project title	
KOKO + Hope & Anchor + Bayham Place Camden, London	
drawing title	scale / date
Proposed Second Floor Plan	1:100 A1 13.04.17
drawing number	drawn / checked
AHA/KKG/GA/102	FR/PC DA
	revision
	N

project title	
KOKO + Hope & Anchor + Bayham Place Camden, London	
drawing title	scale / date
Proposed Third Floor Plan	1:100 A1 13.04.17
drawing number	drawn / checked
AHA/KKC/GA/103	FR/PC DA
	revision
	P

# Sweeper application

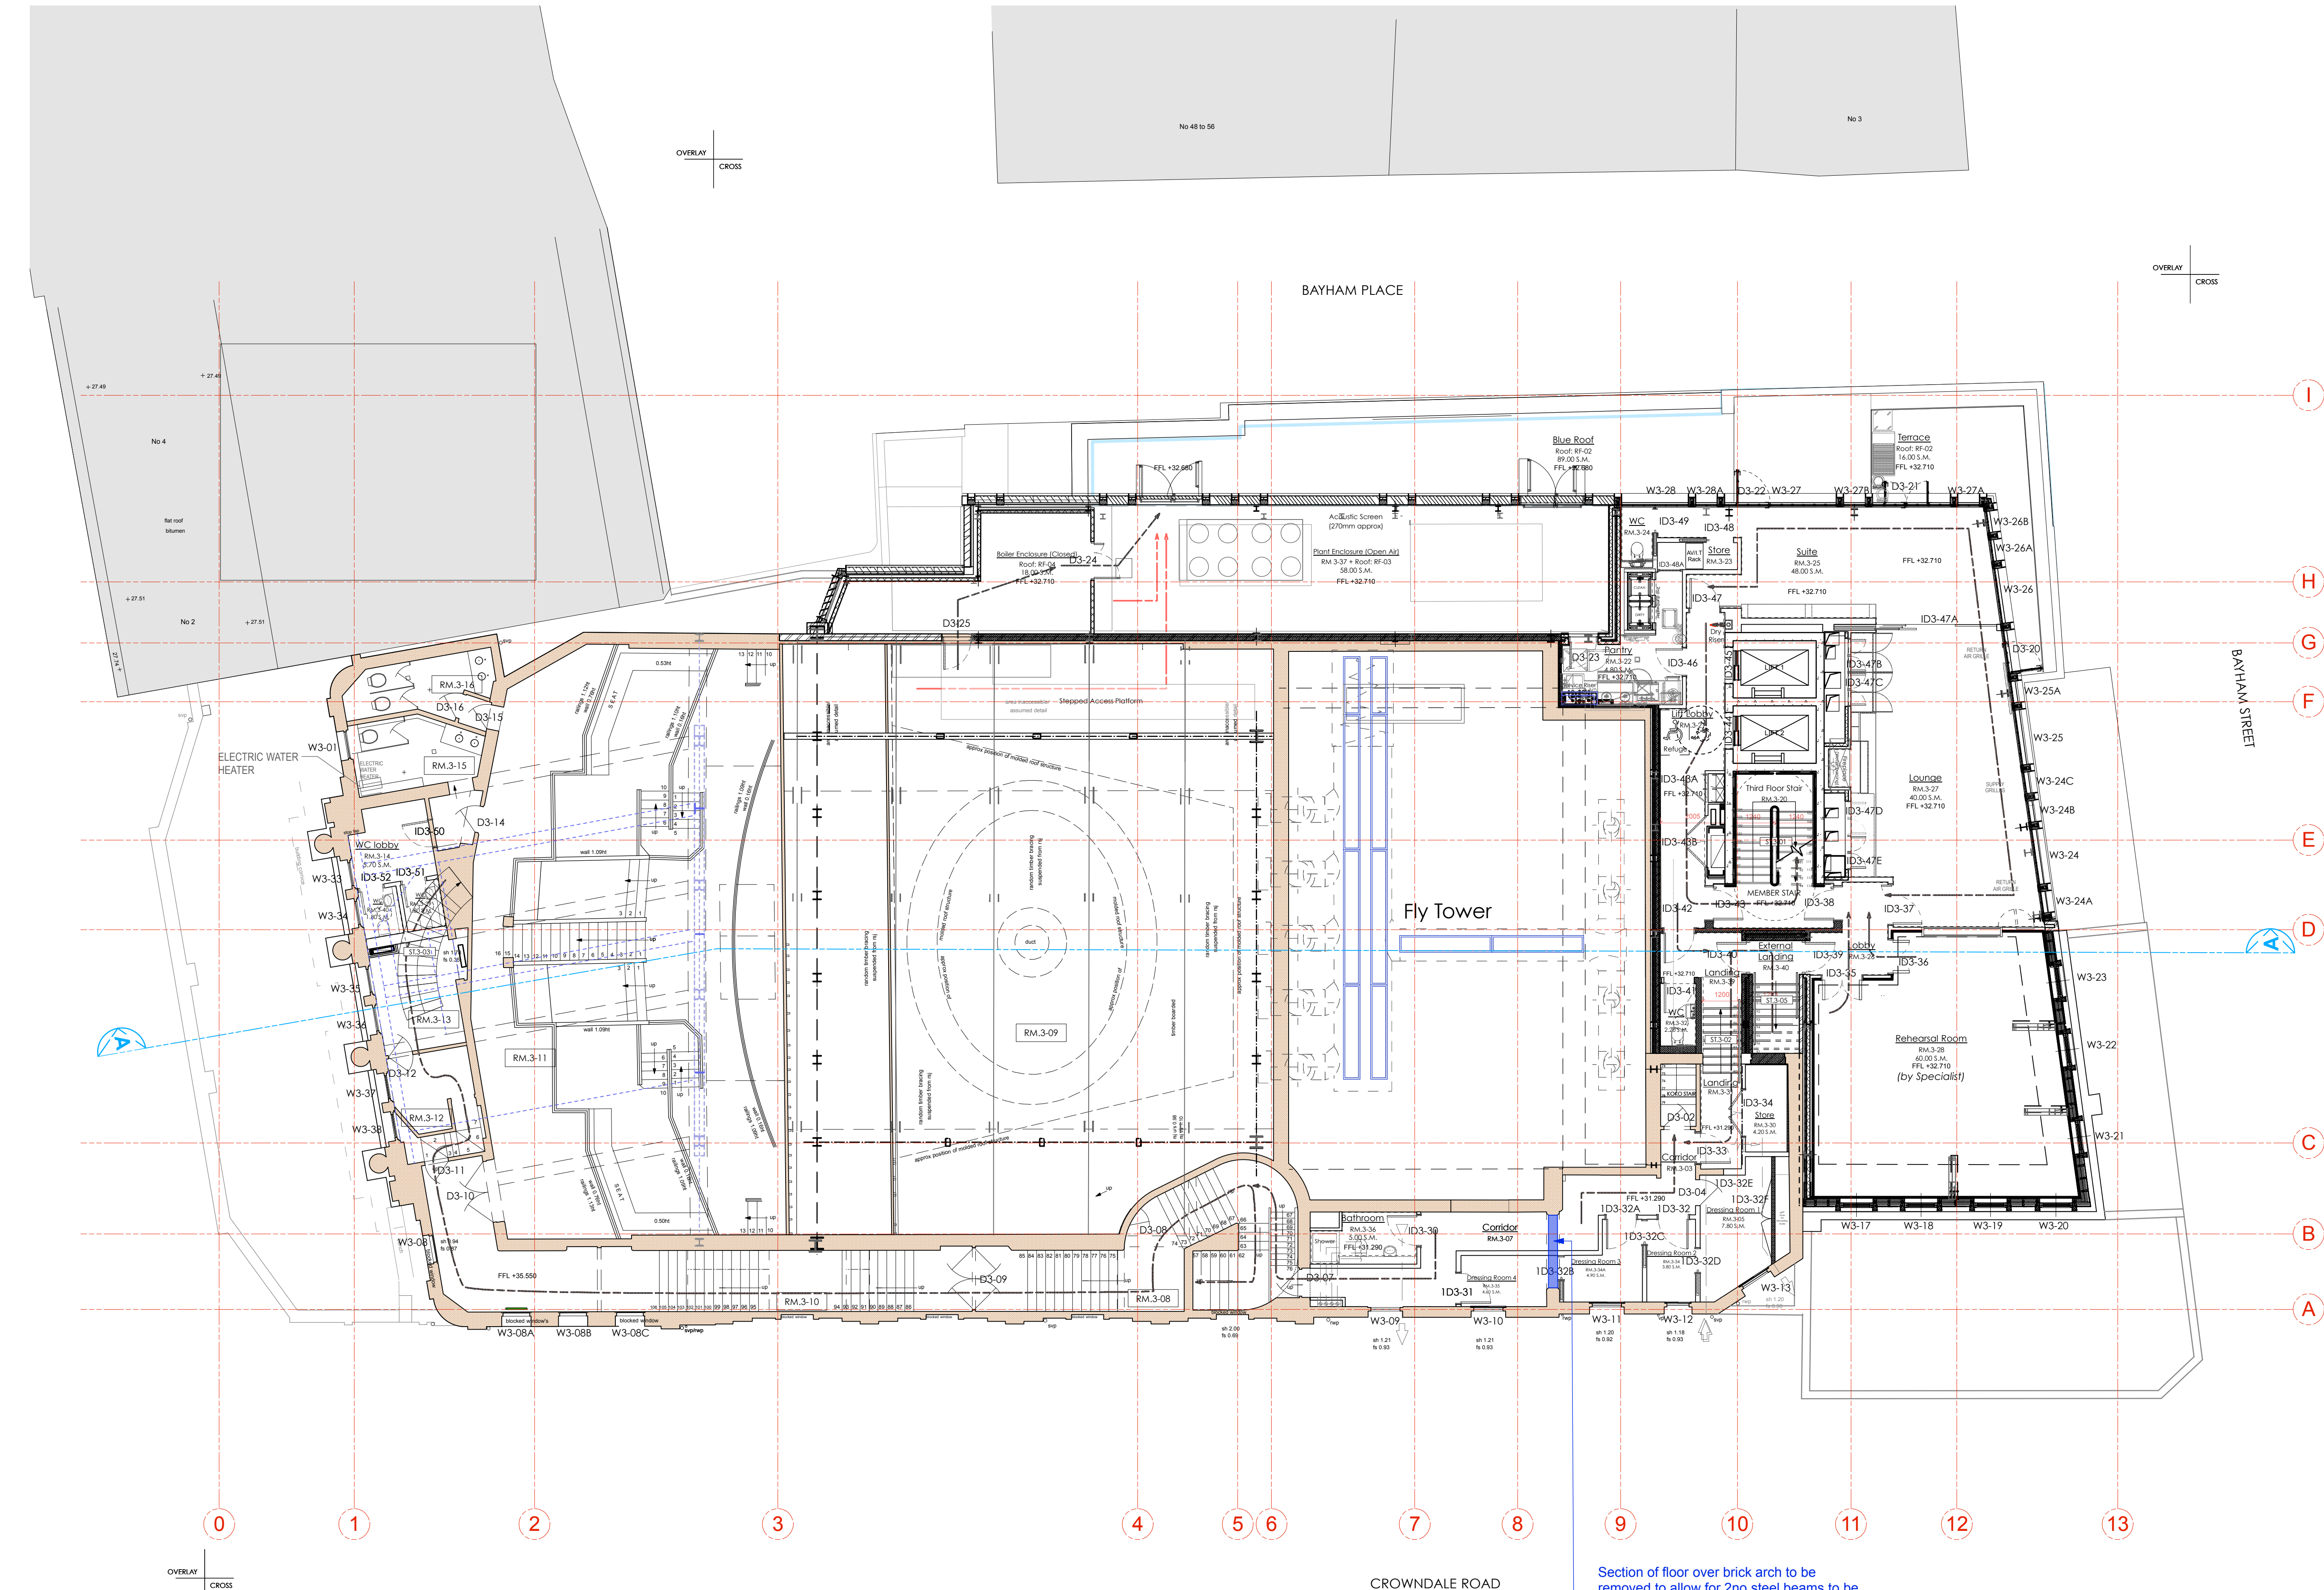
1. Removal and reinstatement at high level H/L.	
	2. Removal and reinstatement at low level L/L	
	3. Removal and reinstatement of walls	
	4. Removal of walls	
	Refer to colour coded legend and annotations 1-6.	
P / 15/12/2020	1. Overhead brick arch to be removed.

project title			
KOKO + Hope & Anchor + Bayham Place Camden, London			
drawing title	scale	date	
Upper & Lower floor Plan Through AV Room	1:20 @ A1	28.06.21	
drawing number	drawn	checked	
AHA/KKR / SK /01	PD	DA	
	revision

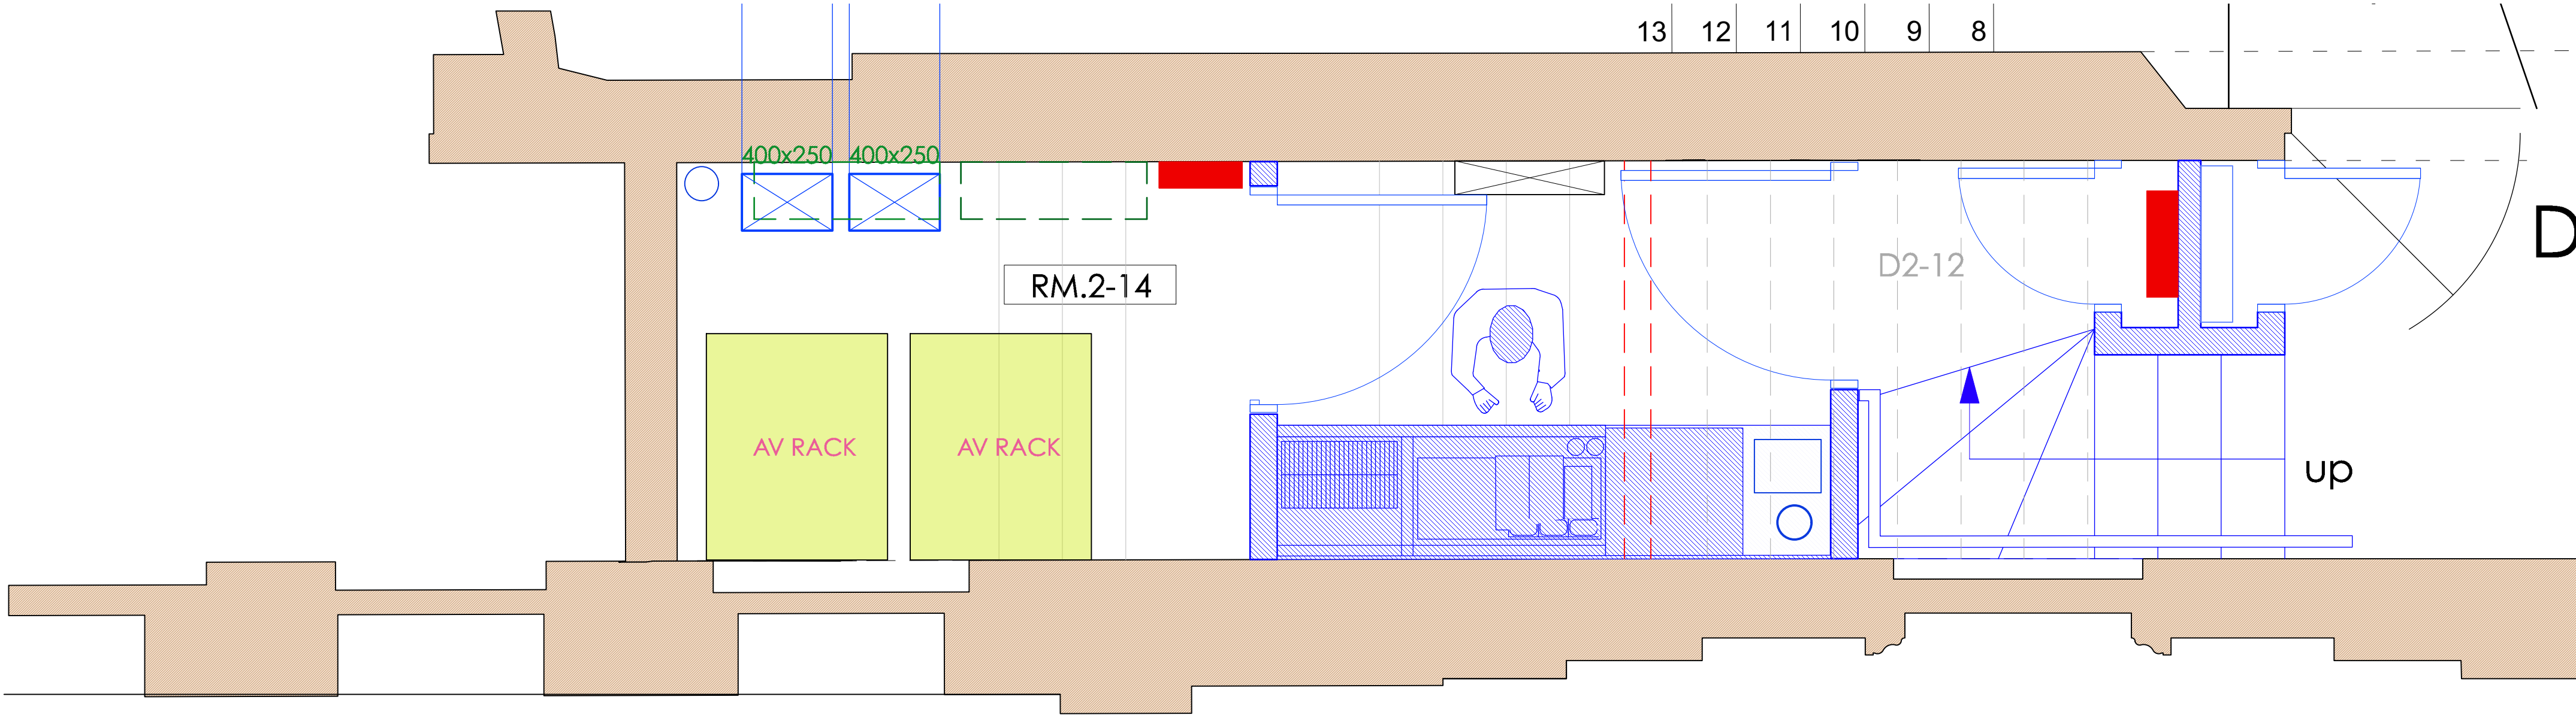
09. AV new layout – increasing  
Room size
